World Forum for Harmonization of Vehicle Regulations**Working Party on General Safety Provisions****131st session**

Other business:**UN Regulation No. 125 (Forward Field of Vision of Drivers)****Proposal for Supplement 5 to the 00 Series, Supplement 4 to the 01 Series, Supplement 4 to the 02 Series and Supplement 1 to the 03 Series of Amendments to UN Regulation No. 125 (Forward Field of Vision)****Submitted by the expert from the International Organization of Motor Vehicle Manufacturers***

Annex 4, Figure 1, amend to read:

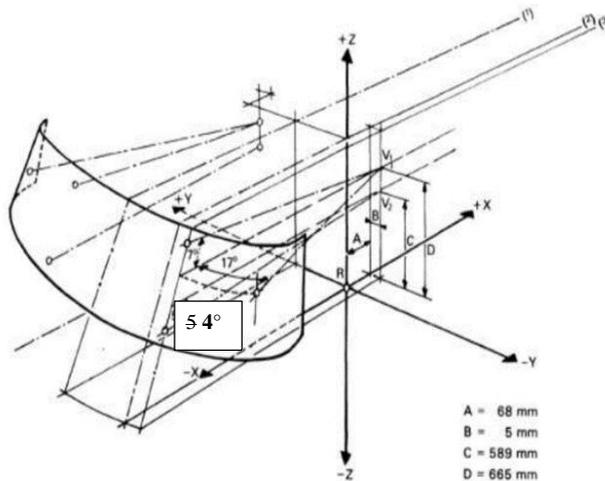
1. In order to meet the visibility requirements of UN Regulation No. 125, there is a notch in the lower edge of the black band of the front window in some vehicles. This is required to satisfy the requirements of UN Regulation No. 125 but is considered to be meaningless for driving vision and needs to be corrected.

5. The obstruction requirements are determined by paragraphs 5.1.2., 5.1.3., and 5.1.4. of UN Regulation No. 125. The datum point specified in 5.1.1. is not used for the obstruction requirements in vehicle testing under UN Regulation No. 125. While there is a proposal to delete 5.1.1., doing so would eliminate all upper and lateral restrictions. Therefore, it is considered appropriate to retain the upper and lateral aspects of 5.1.1. as they are, but to change the position of the datum point for the lower side from 5° to 4° .

"5.1.1.3. A lower vertical datum point forward of V2 and ≤ 4 deg. below the horizontal;"
